Addendum Three

The Renovations & Restorations of the Westport Community Center

Issued: Monday, December 19, 2016

OPTION C

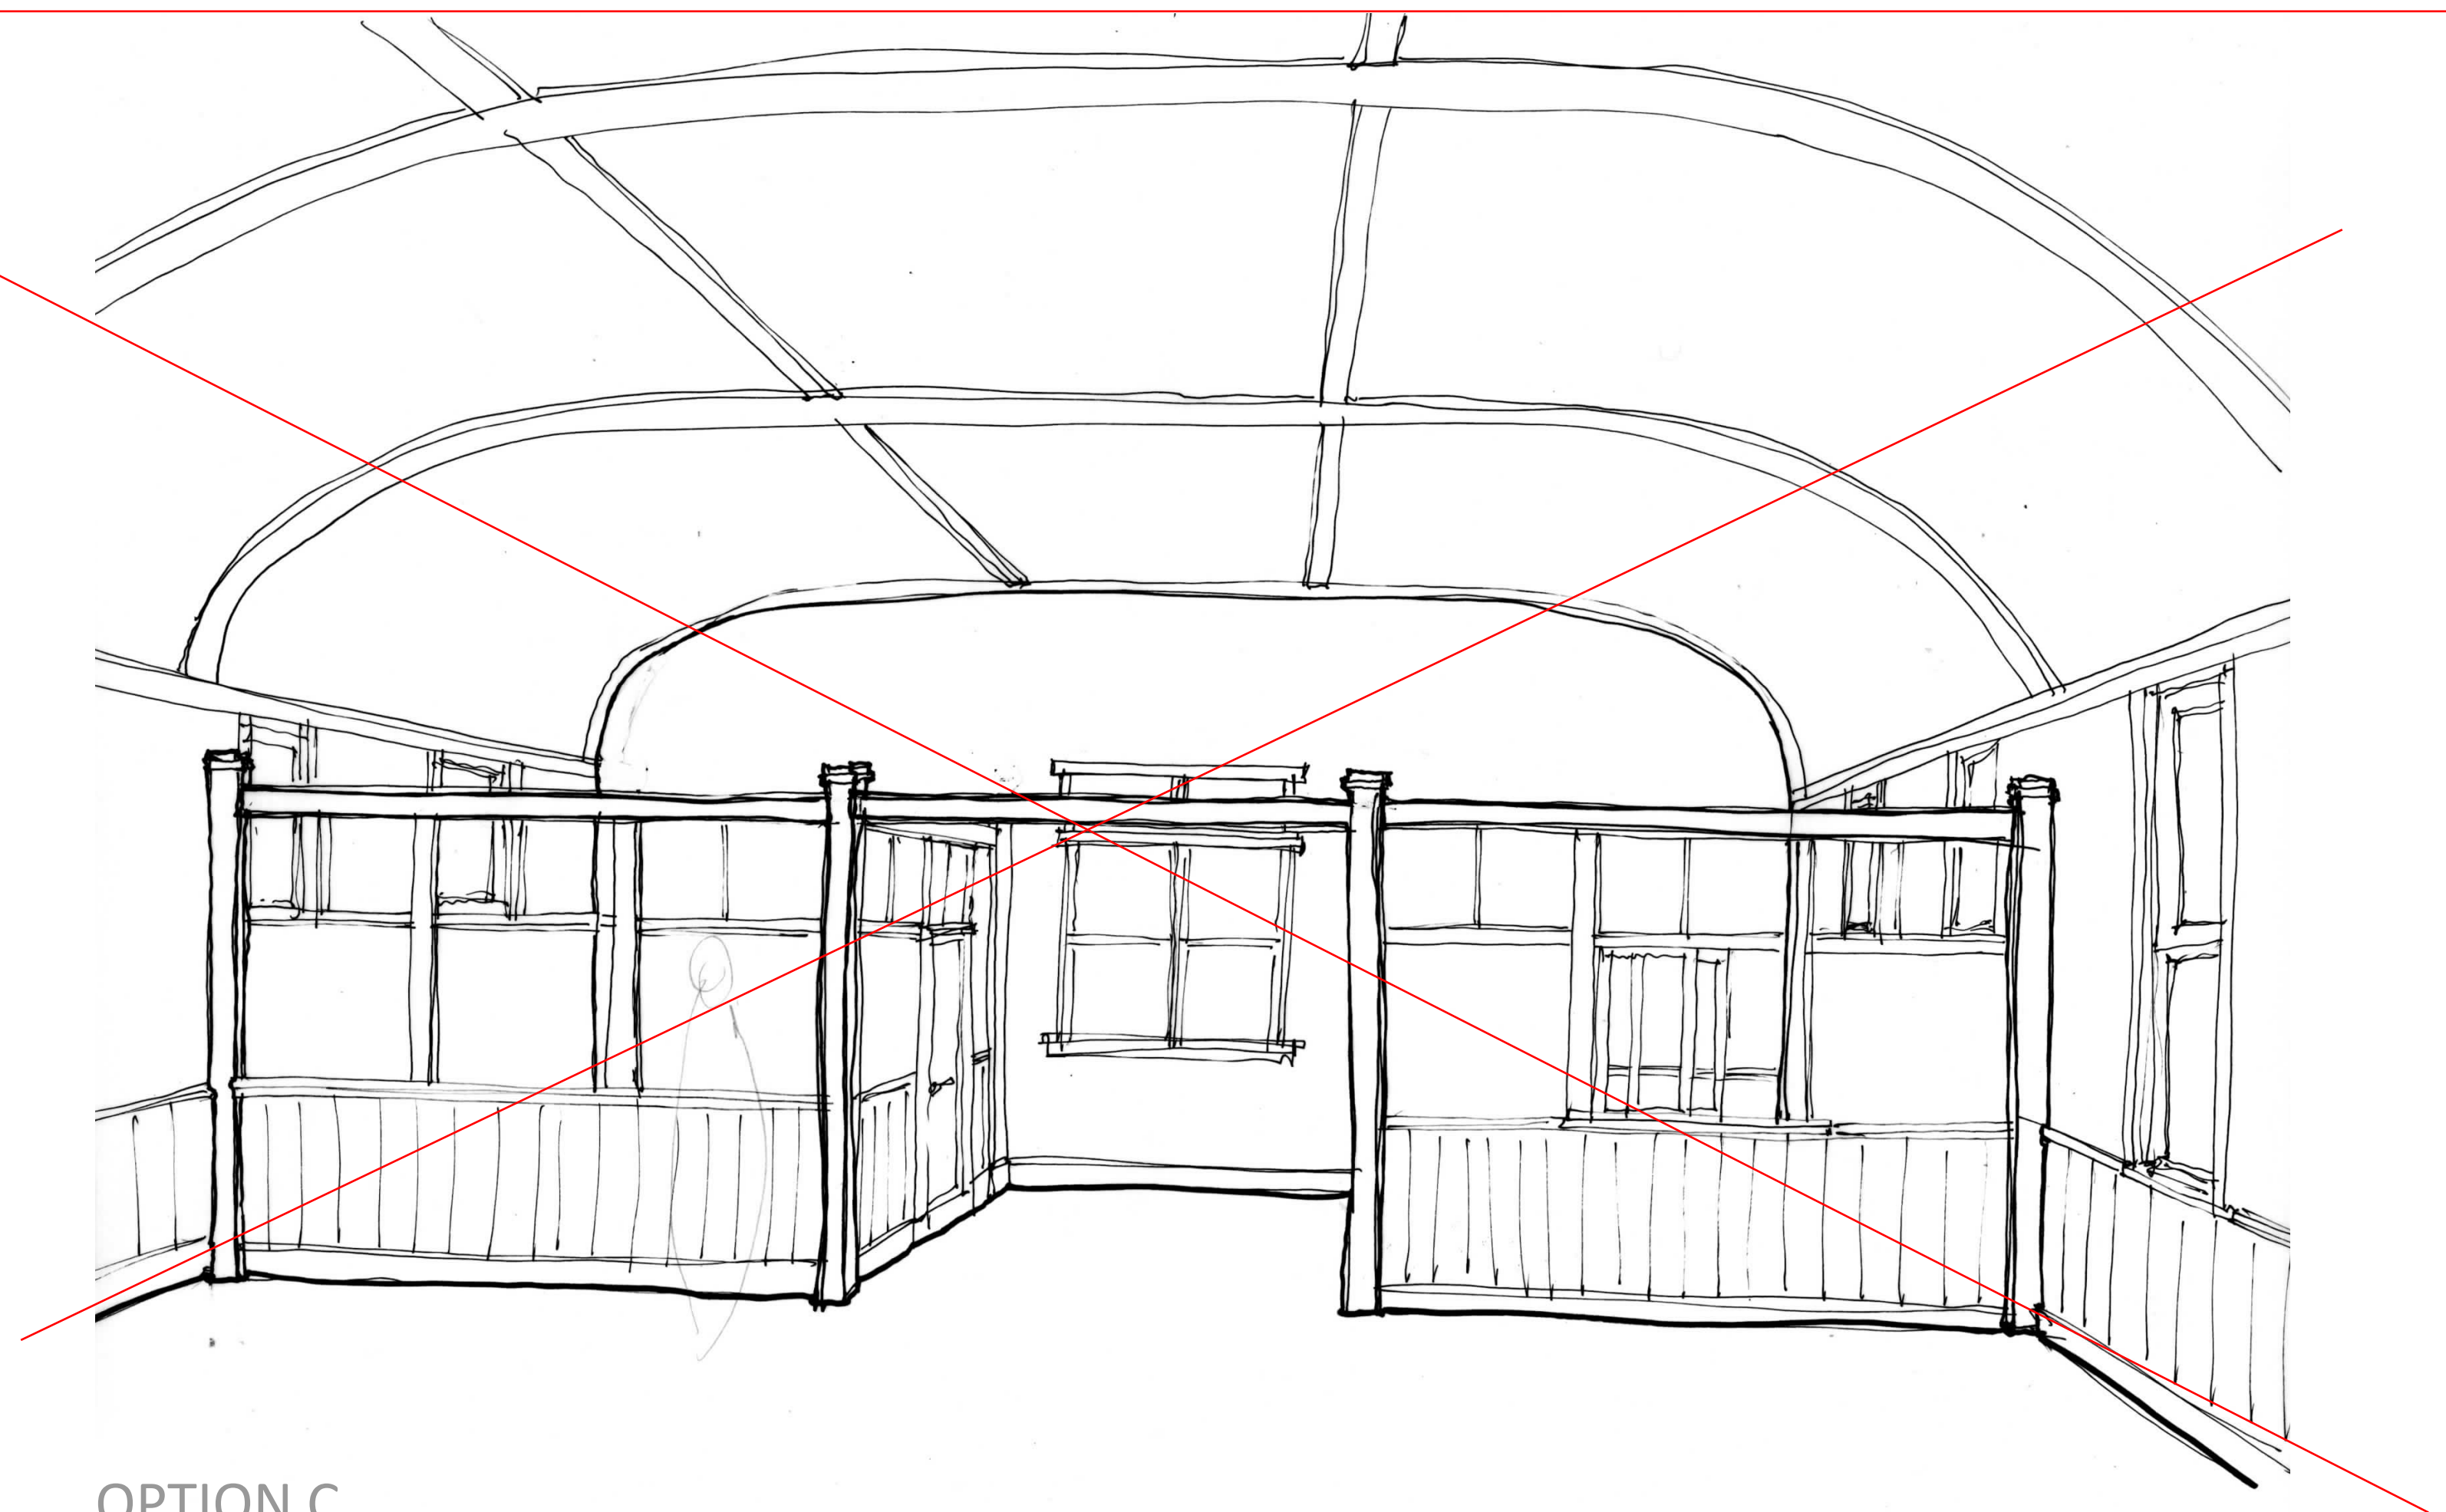
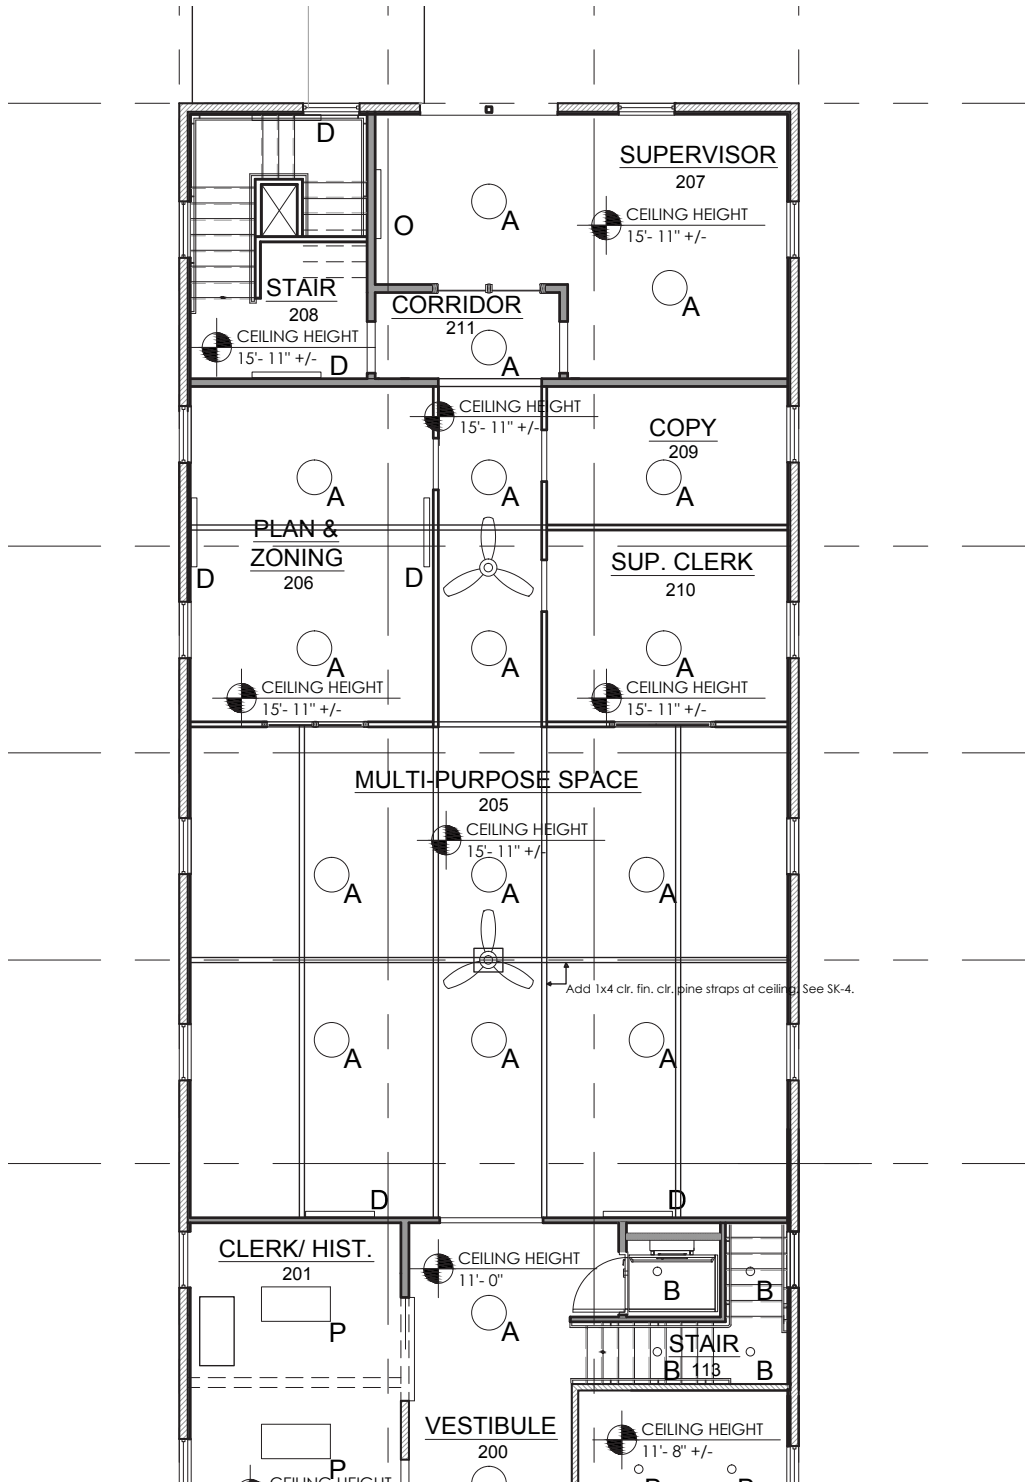
22. I am unable to find any drawing depicting woodwork on the vaulted ceiling on the main floor, it is scheduled and specified.

The only wood on the ceiling of the meeting room shall be the straps as shown on the attached sketches SK 4 & 5. Otherwise the ceiling is gypsum wallboard.
